MIL-B-60884C(AR)
AMENDMENT 2
29 June 1979
SUPERSEDING
Amendment 1
31 January 1979

MILITARY SPECIFICATION

Binocular: M19

This amendment forms a part of Military Specification MIL-B-60884C(MU), dated 28 June 1974.

FIG 2

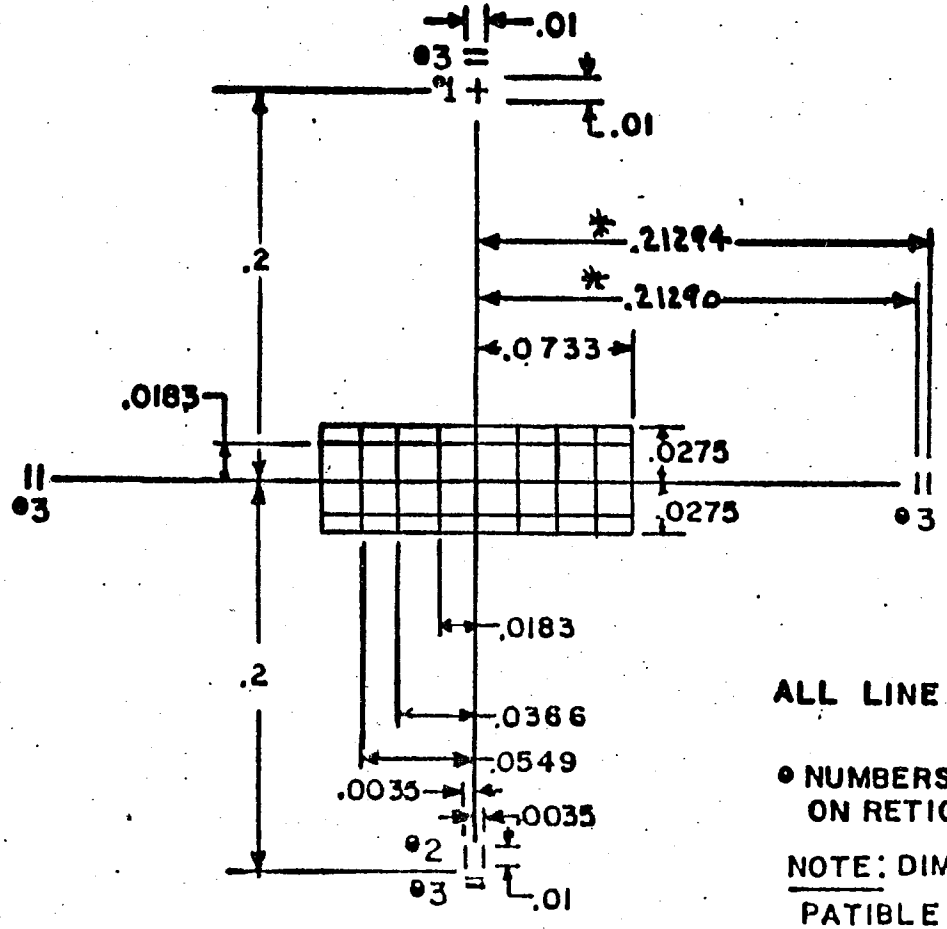
* Figure 2 - Delete and substitute new Figure 2.

ALL LINE WIDTHS .0006 +.0002

• NUMBERS TO BE PLACED ON RETICLE

NOTE: DIMENSIONS ARE COMPATIBLE ONLY WITH 10" COLLIMATOR F10547434 W/ DOUBLE COLLIMATOR F7680840

SPECIAL RETICLE
